OUTCOMES COMMITTEE

Issue: Bonnyrigg Living Communities Project – Modification to Concept Plan.
Premises: Bonnyrigg Housing Estate, Bonnyrigg.
Owner: Fairfield City Council, Department of Housing.
Applicant: Becton Pty Ltd (Attachment A)
Zoning: - Fairfield LEP 1994: Residential 2(b), Residential 2(c), Open Space 6(a)
- Draft Fairfield LEP 2011: R1- General Residential, RE1 – Public Open Space
Submissions: Yes (Attachment A)

FILE NUMBER: 11/03263

The Department of Planning and Infrastructure (DP&I) has notified Council of public exhibition of proposed modifications by Becton Pty Ltd, to the Bonnyrigg Living Communities Project Concept Plan.

Park Location Plan

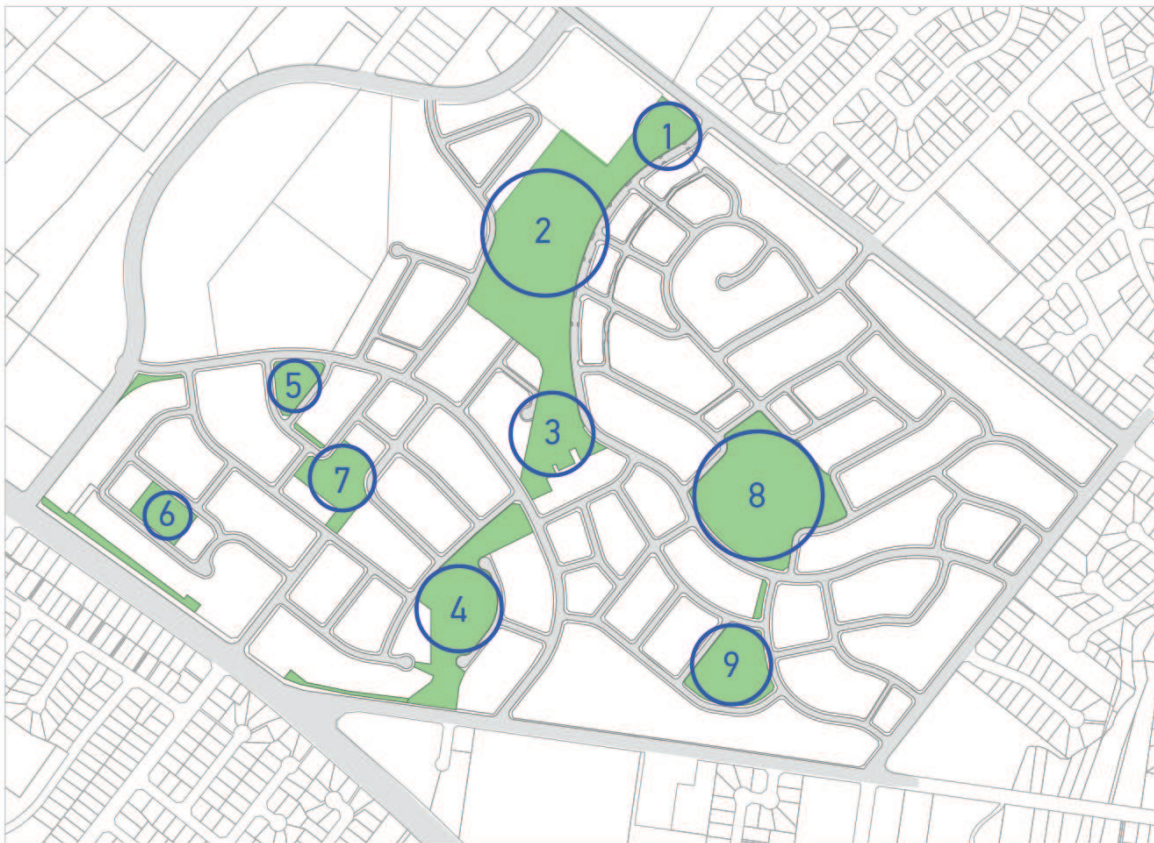
Parks 5, 6 and 7 have been reconfigured from the original concept, while the extent of parks 4 and 8 have been modified. The original features, structures, amenities and furniture have largely been retained from the original concept proposals. Information on other changes to the embellishment of parks are detailed under the next heading.

The variations to the parks (above) are noted as follows:

- **Park 3 – Middle Valley Creek Community Centre Park**
 - a. Master Plan layout modified – include community nursery and switches community centre and Newleaf offices

- b. Men's Shed not identified on Park 3 Plan (page 113)
- **Park 4 – Upper Valley Creek Park**
 - c. Basketball court reduced to ½ court – the full court is recommended to be retained.

- **Park 5 & 6 – Bonnyrigg Avenue Entry and Village Park**
 - d. Spaces completed reconfigured in different locations
 - e. Park 5 incorporates significant local tree (to be retained)

- f. Prior use and nature / detail largely maintained
 - g. Landscaping provided at Tarlington Parade and Bonnyrigg Avenue
- **Park 7 – Forest Park**
 - h. References to low seating/retaining wall to sunken play area, shelter/seating, shareway connection across site with lighting

- i. Location of tennis wall may need to be discussed further with respect to noise impact on residences
- **Park 8 – Hilltop Park**
 - j. Minor variation in shape and extent, same uses/facilities proposed.

Community Centre Plan

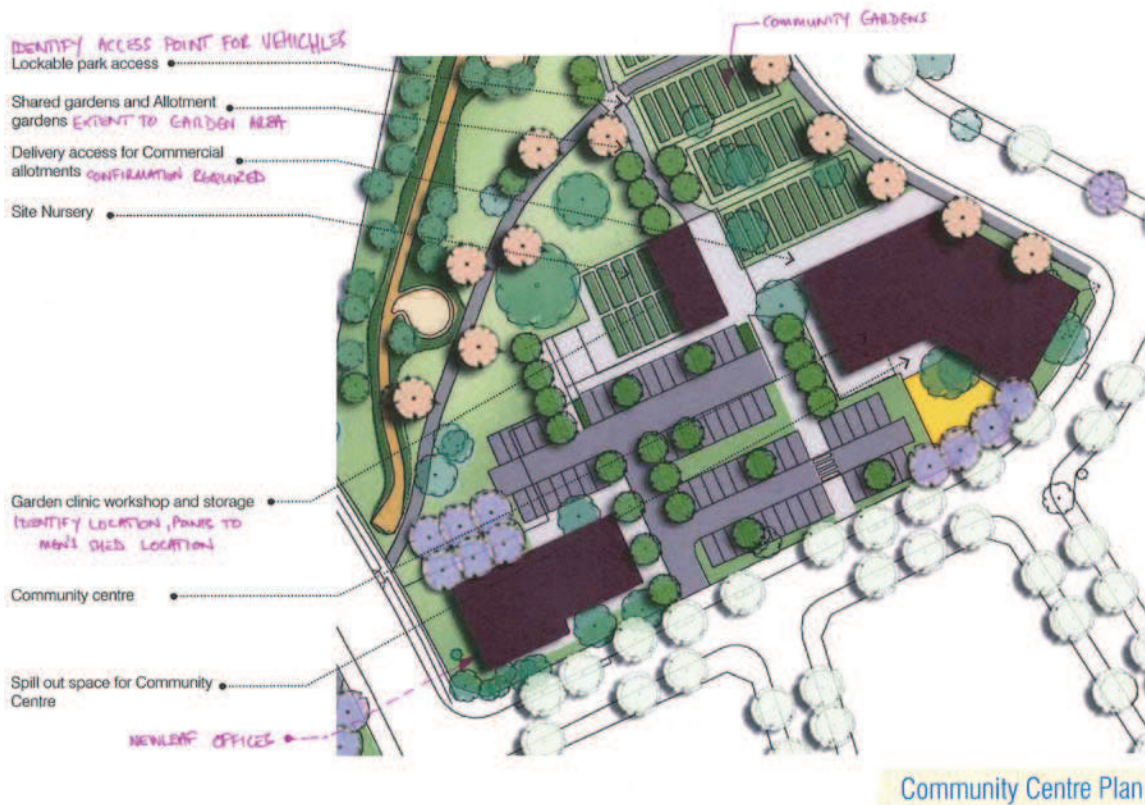
The initial discussions with Council Officers in relation to amending the master plan for the community centre identified the following:

- Preferred location for the community building taking into account the early delivery timeframe for the Newleaf Community Offices
- The location of the men's shed
- The inclusion of the community nursery in this area
- The location and orientation of the community gardens

The plan included in the modification should be amended to reflect (see graphic below):

1. Location of the men's shed and community garden storage and cupboard area, which is separate to the nursery
2. Location of the Newleaf Offices
3. Location of park access (vehicular for maintenance and servicing)
4. Correctly identify the Newleaf offices, community gardens and delivery access

BONNYRIGG TERRACES

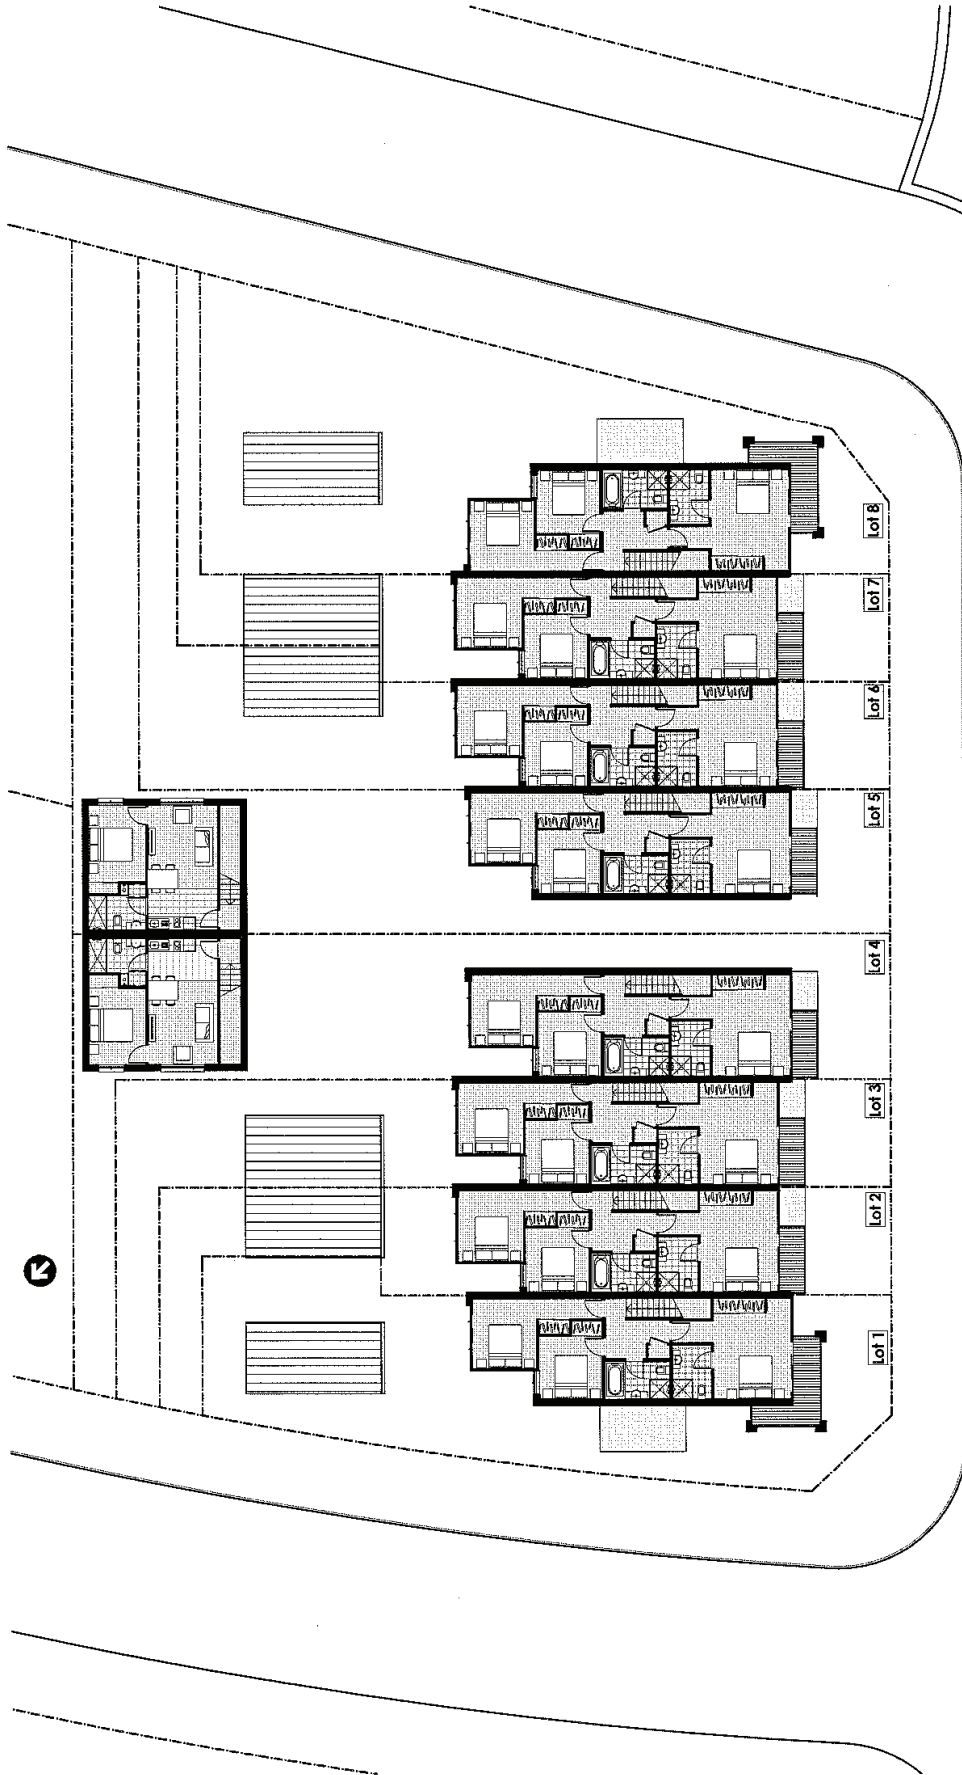
Two of the central terraces shown in Attachment B include a detached 'flatette' toward the rear boundary of each lot. This component of terrace housing typology is not supported as:

- It obstructs the provision of formal laneway at the rear of the terraces and does not achieve provision of dual street frontages as required by the proposed masterplan controls (above) for terrace housing.
- The flatette has limited residential amenity, particular in terms of solar access and results in overshadowing of the rear yards of the terrace housing
- There is inadequate provision of private open space (including lack of balconies).
- The design is not conducive to the principles of accessible housing.
- The arrangement of creating driveways via a shared right of access is also unacceptable as in the longer term getting neighbours to agree to maintenance arrangements without strata rules to assist the process increasingly leads to problems

In light of the concern with the deficiencies in public open space (below) associated with the modification to the concept plan, it is recommended that Council endorse the following additional criteria to ensure that both terrace housing and three storey walk up apartments be located so as to maximise access to public open space and the community facilities. Terrace housing should also be orientated to maximise solar access as follows;

- Terrace housing and 3 storey apartments are to be located adjacent to or directly opposite public open space or the proposed community precinct.
- The lots associated with terrace housing are to have a predominantly north south orientation so as to maximise solar access
- Terrace housing shall have at least two street frontages so each unit in a terrace has frontage to a road and the rear separate access to a formal laneway.
